SERVICE INSTRUCTION SK-SI001 Rev NC Page 1 of 2

SUBJECT: PROPELLER LEVER SPRING RETROFIT INSTRUCTIONS

MODELS AFFECTED: CCK-2000 AND CCX-2000 S/N 0001 THROUGH 0072

Figure 1 – Replacement Components Installed

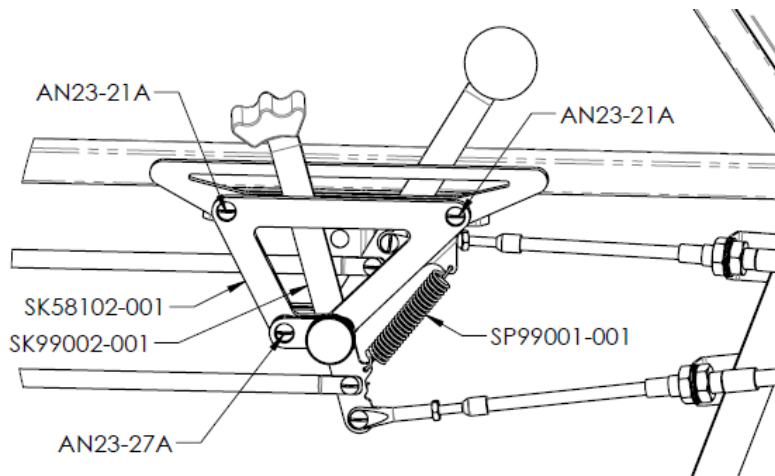
1. Read all instructions before beginning any work.
2. Remove the left center interior panel. (AMM Chapter 25-00)
3. Disassemble the forward controls in order to remove the forward propeller lever (XC99002-001) and spacer block (SC58102-004). (AMM Chapter 76-00)
4. Reassemble the forward controls with the replacement parts. Replace the propeller lever with SK99002-001, and replace the spacer block with SK58102-001. Add an extension spring (SP99001-001) between the spacer block and the prop lever as shown in Figure 1.

- b. Verify that the throttle and propeller levers do not hit the interior panel or the AN23-21A bolts in the control assembly (see Figure 1). The movement of the throttle and propeller levers should be limited by the mechanical stops firewall forward, not the interior panel or control assembly bolts.

- c. Verify that the propeller lever does not spring forward when the lever is pulled to the aft position. If there is a tendency of the lever to spring forward, the friction in the system may need to be increased by tightening the bolts that mount the control assembly. In particular, tightening the AN23-27A bolt noted in Figure 1, will increase the friction in the system.
